# Access Compliance Report

## Public Rights-of-Way

Intersection ID: 31934	Main Street: STEELE_CREEK_RD	Cross Street: BRANCH_BEND_LN	Location: SE
ADA ID: 787DE1D7C6D5	Ramp Type: PerpDiag	Initial Pass/Fail: Fail	Overall Compliance: No
Severity Score: 17.5			
Codes/Mitigation Info/Possible Solution		Field Measurements/Component Compliance

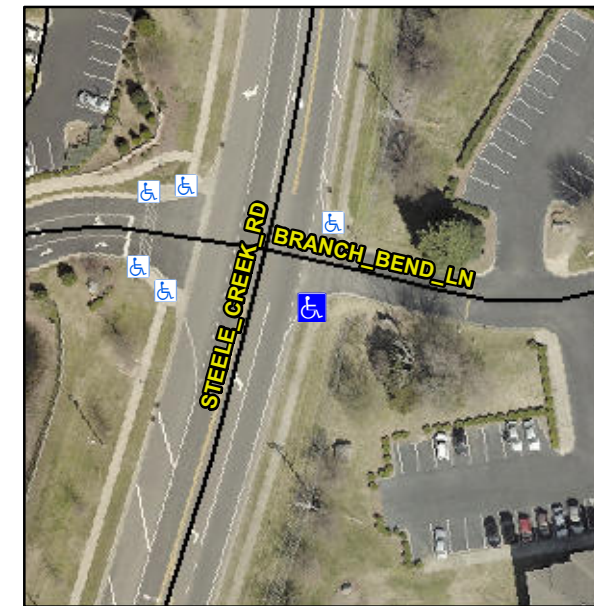
**Not Found, R304.5.1**

Compliance	Description	Data	Compliance	Description	Data
N/A	Ramp Length (in)	111.0	Yes	Ramp Slope (%)	5.7
No	Ramp Width (in)	35.0	Yes	Ramp XSlope (%)	0.1
N/A	Flare Type LT	N/A	N/A	Flare Type RT	N/A
N/A	Flare Slope LT (%)	N/A	N/A	Flare Slope RT (%)	N/A
N/A	Flare Traversable LT?	N/A	N/A	Flare Traversable RT?	N/A
N/A	Landing Length (in)	N/A	N/A	DWS Provided?	N/A
N/A	Landing Width (in)	N/A	N/A	DWS Contrast?	N/A
N/A	Landing Slope (%)	N/A	N/A	DWS Length (in)	N/A
N/A	Landing X Slope (%)	N/A	N/A	DWS Full Width?	N/A
N/A	Landing Curb? (Y/N)	N/A	N/A	DWS Offset (in)	N/A
N/A	Shared Landing?	N/A			
N/A	Gutter Ponding?	N/A	N/A	Gutter Slope (%)	N/A
N/A	Gutter Lip Ht (in)	N/A	N/A	Gutter X Slope (%)	N/A
N/A	Painted X Walk1?	No	N/A	Painted X Walk2?	No
	X Walk 1 Direction	To NE		X Walk 2 Direction	To NW
N/A	X Walk 1 Width (in)	N/A	N/A	X Walk 2 Width (in)	N/A
	X Walk 1 Slope (%)	1.6		X Walk 2 Slope (%)	0.8
	X Walk 1 X Slope (%)	2.2		X Walk 2 X Slope (%)	3.3

**Remove & Replace Curb Ramp With Two New Directional Ramps or Equivalent.**
